Environmental Minor Project Refinement Form

Project Name: West of Devers Upgrade **Request Prepared By:** Sylvia Granados

Project Date Approval Required: 6/9/2020 **Variance Request No.:** 37

Southern California Edison
West of Devers Upgrade Project
Proposed Scour Protection Areas
MPR #37

FIGURE 1

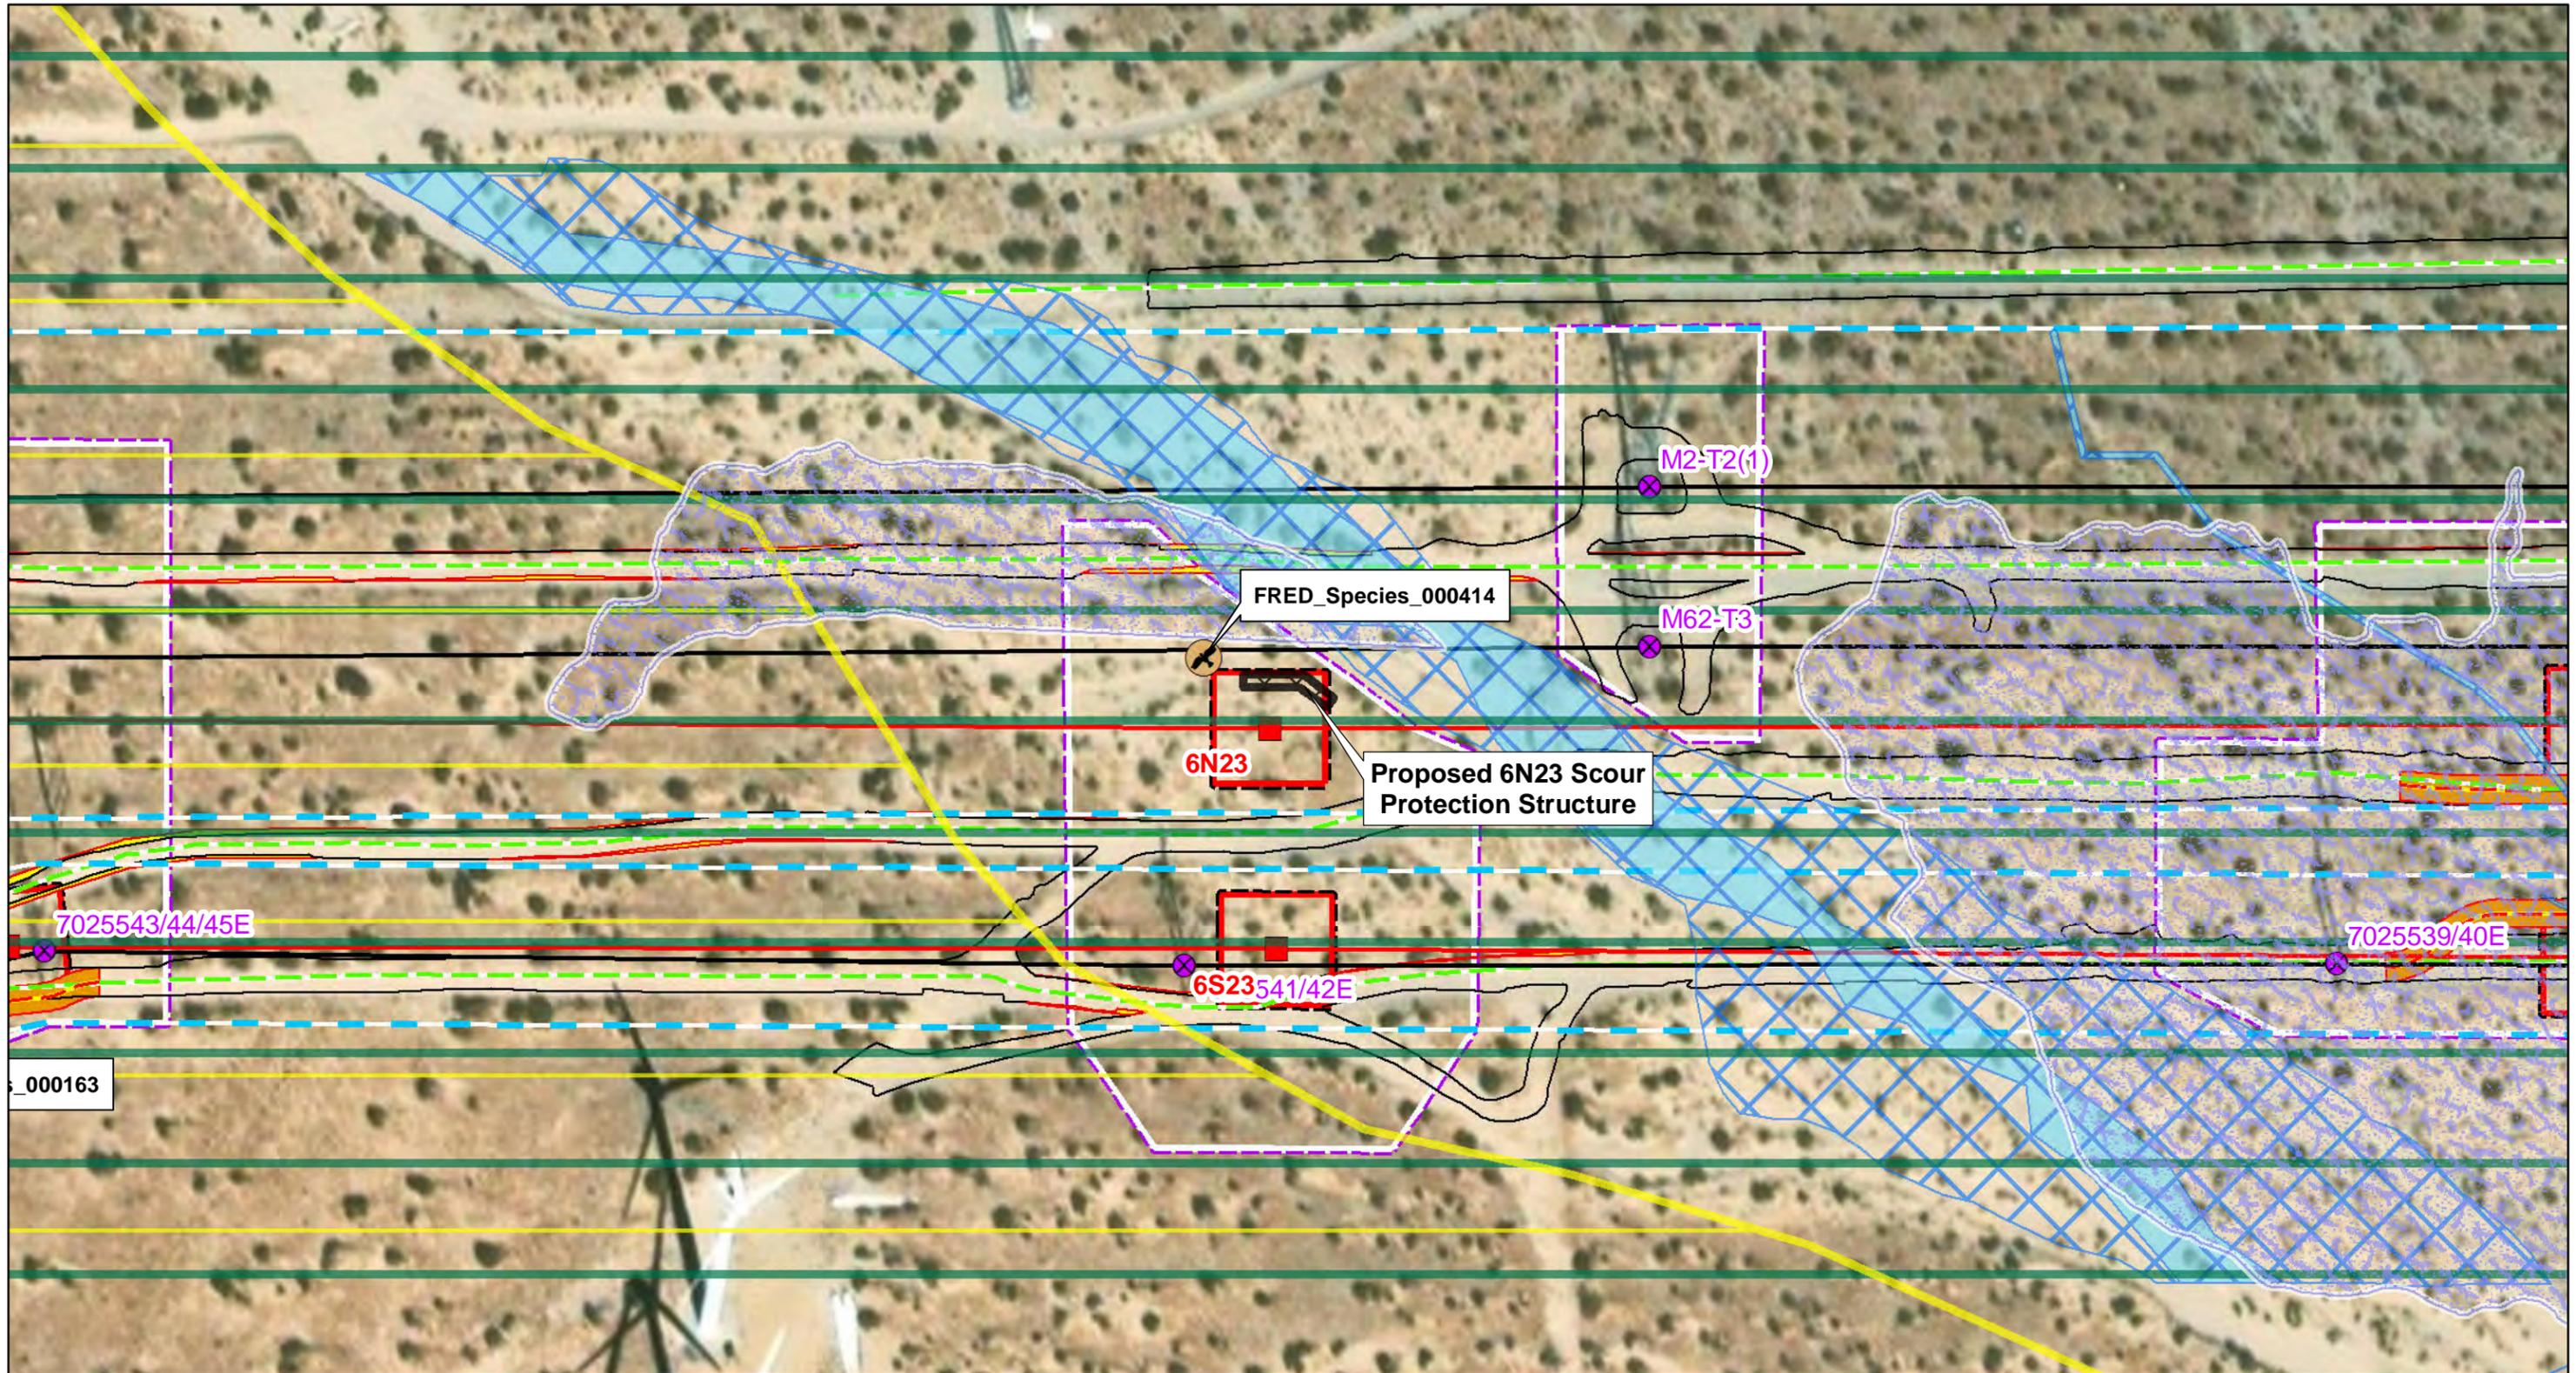
6N23 - Expected high velocities near the site require a high-class rip-rap due to proximity of the wash located east of the site. Due to the size of rip-rap, a windrow revetment is the recommended countermeasure. The permanent impacts associated with these countermeasures total 0.01-acre of the previously approved disturbed tower pad area. See Figure 1, page 1 and Scour Analysis Appendix B attached for details.

FIGURE 2
Page 1 of 3
Southern California Edison
West of Devers Upgrade Project
Proposed Work Areas
MPR #37

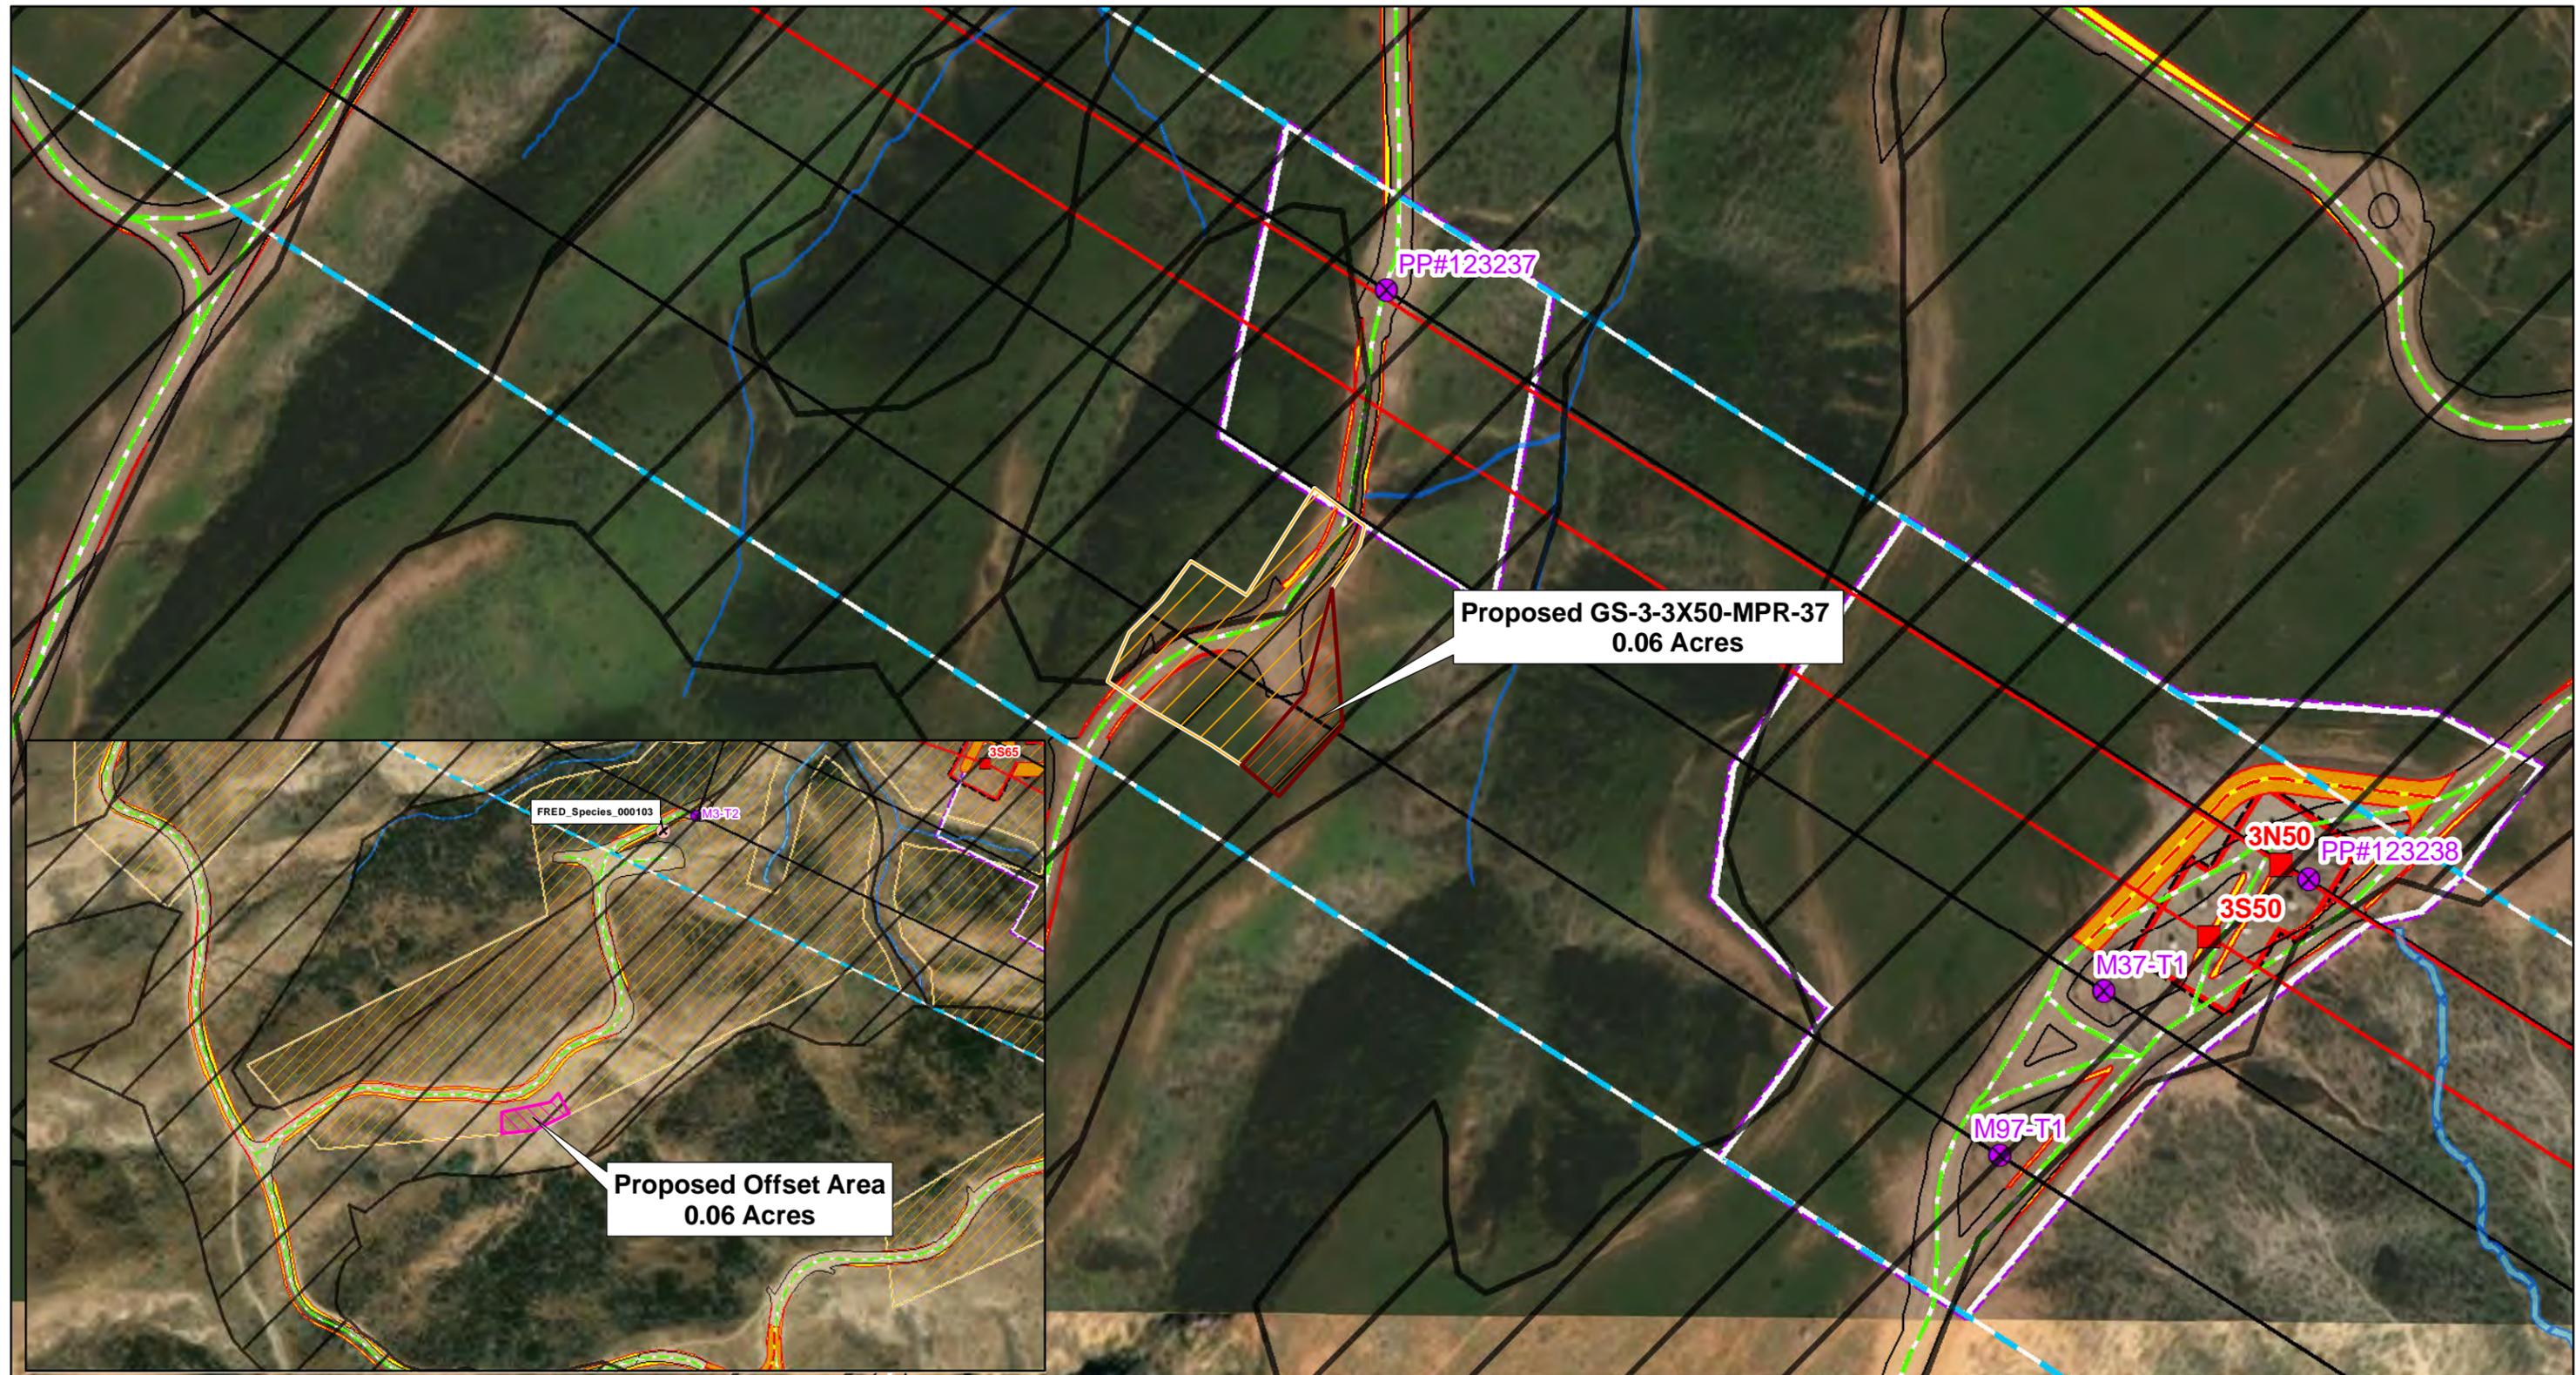
A new temporary 0.81-acre work area located immediately adjacent to the north side of the Vista Substation is required to stage material and equipment to facilitate the fiber-optic cable and new conduit installation from 220-kV Structure

2N36 to an existing manhole inside the Vista Substation, as shown on Figure 2, page 1. The new work area will not require site improvements in preparation for use since the area is paved.

FIGURE 2
Page 2 of 3

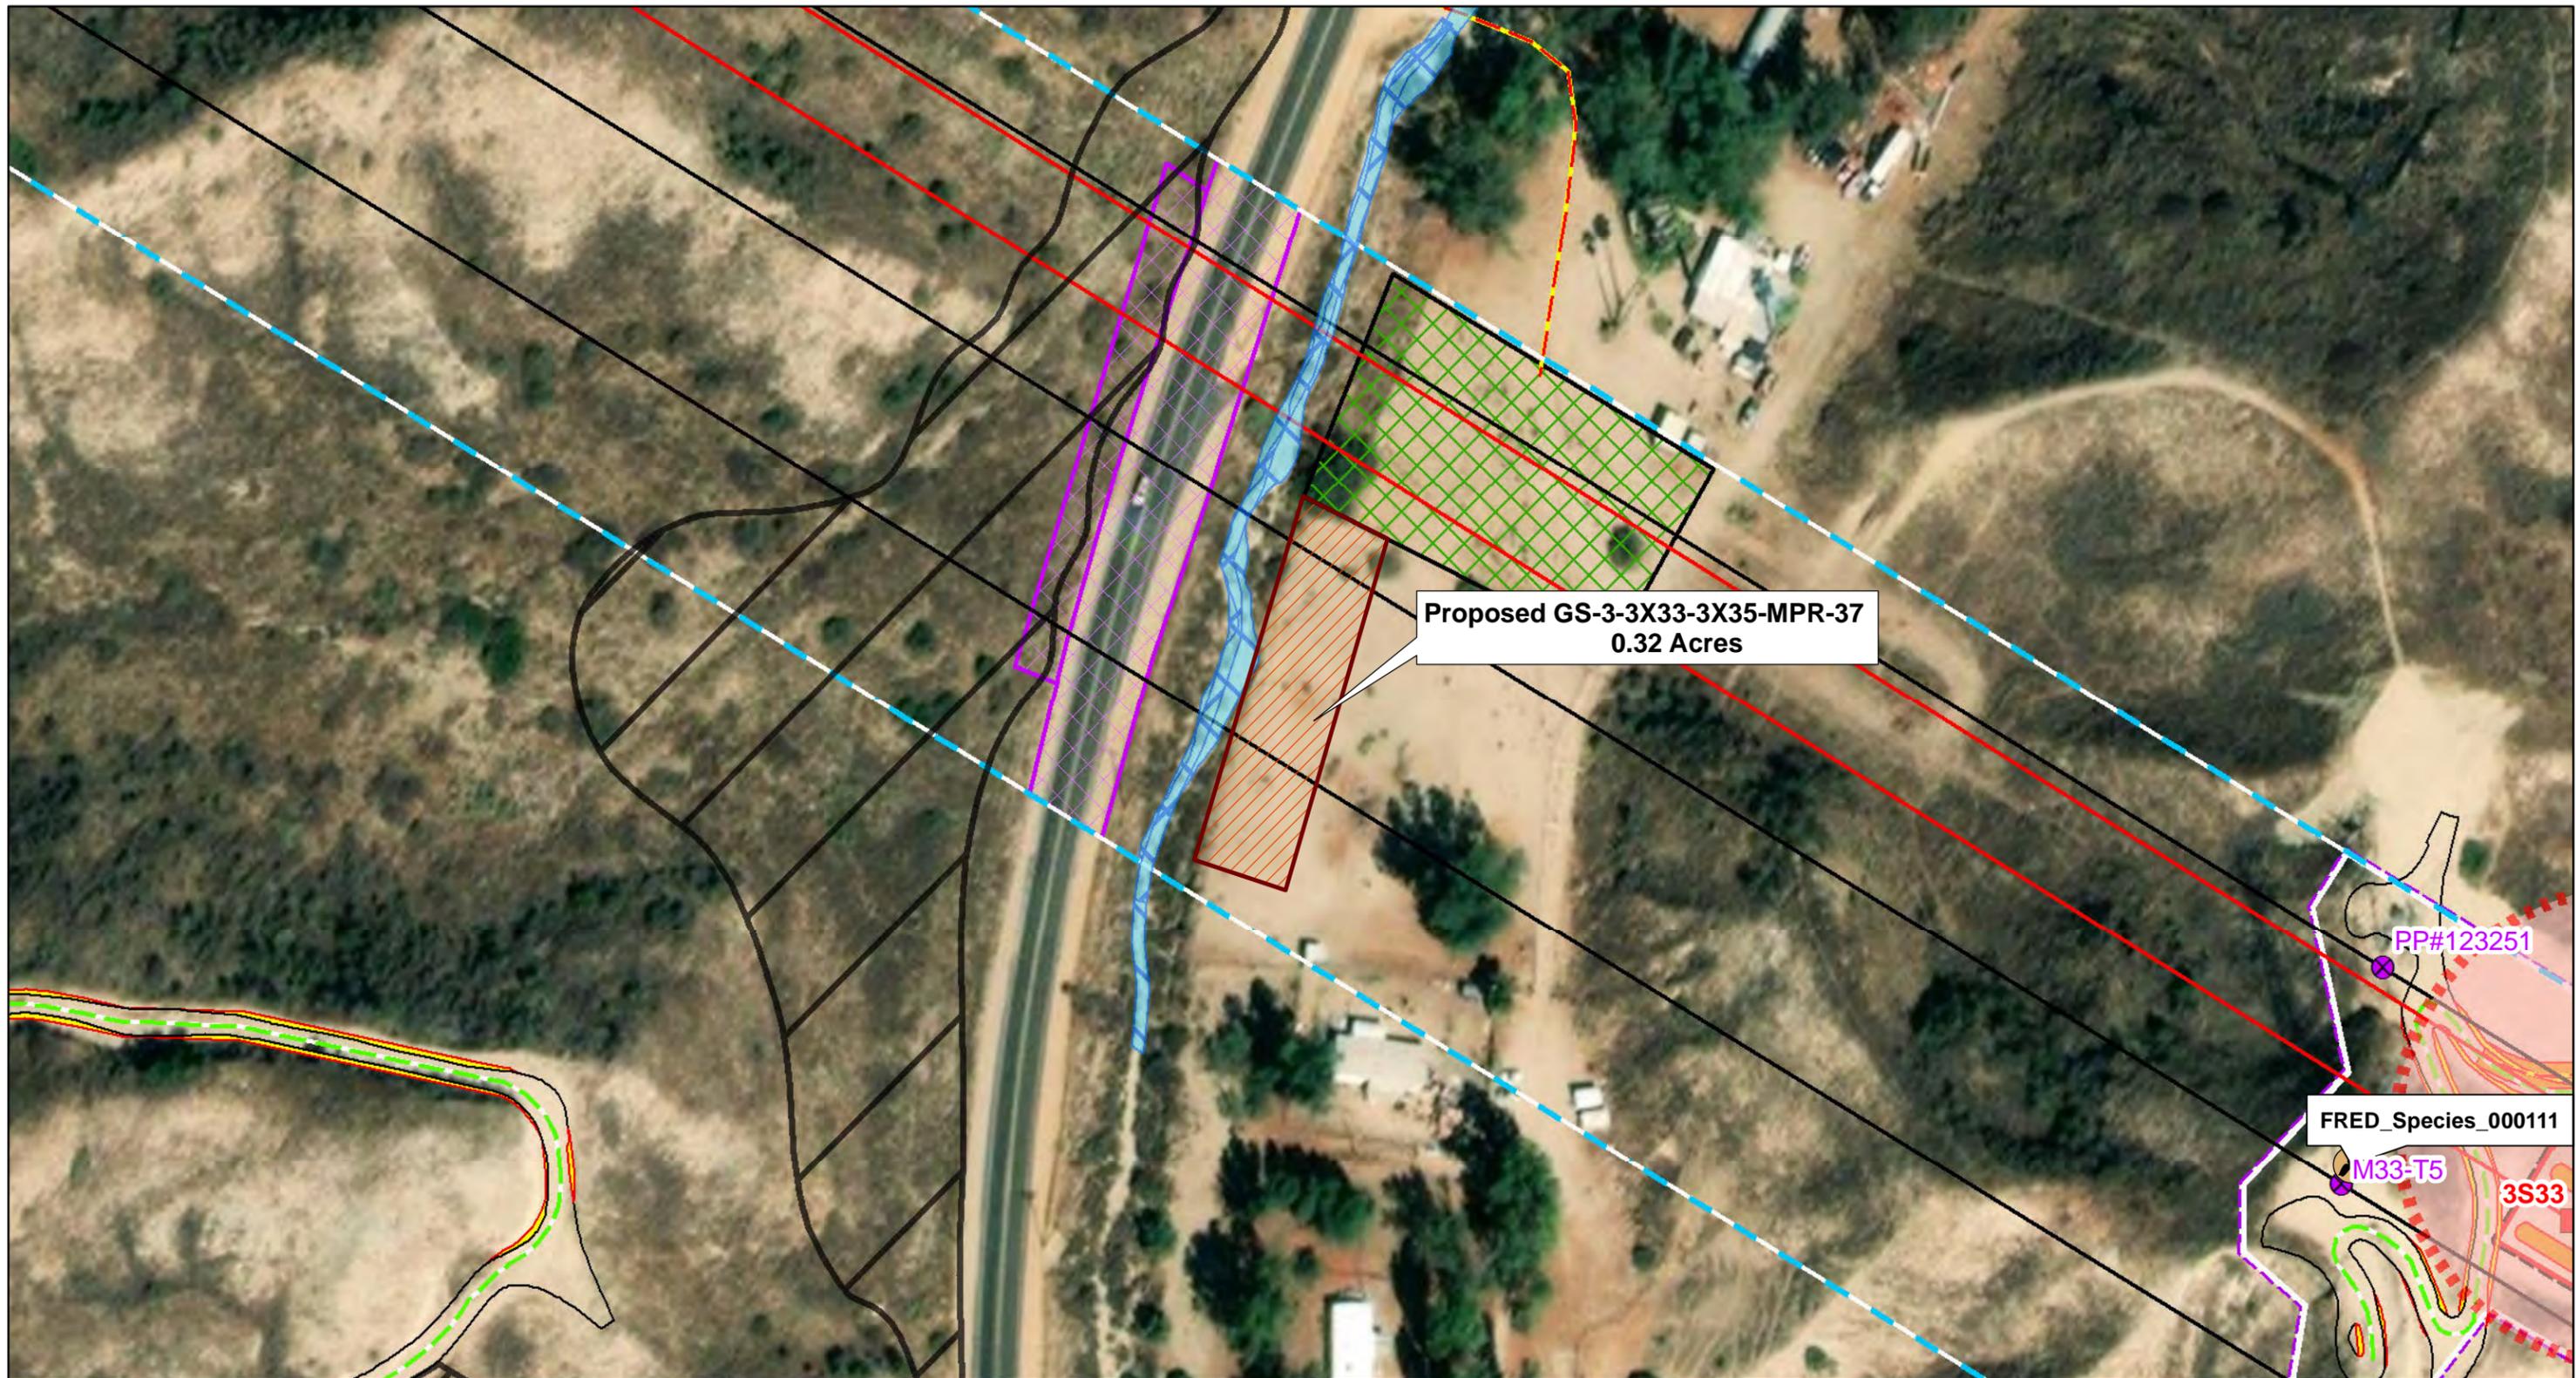
A new temporary 0.06-acre work area located immediately adjacent to the east side of WSS-3-3X50-MPR-34 is required to safely stage material and equipment associated with the wire removal from Supersites 3X29 to 3X50 and 3X51 to 3X65. The new work area will be accessed from WSS-3-3X50-MPR-34, as shown on Figure 2, page 2.

To minimize temporal habitat loss, a portion of previously approved work area in San Bernardino County, which was determined to no longer be necessary for construction, will be removed from the project data and avoided to offset mapped habitat impacts to GS-3-3X50-MPR-37 (Figure 2, Page 2).
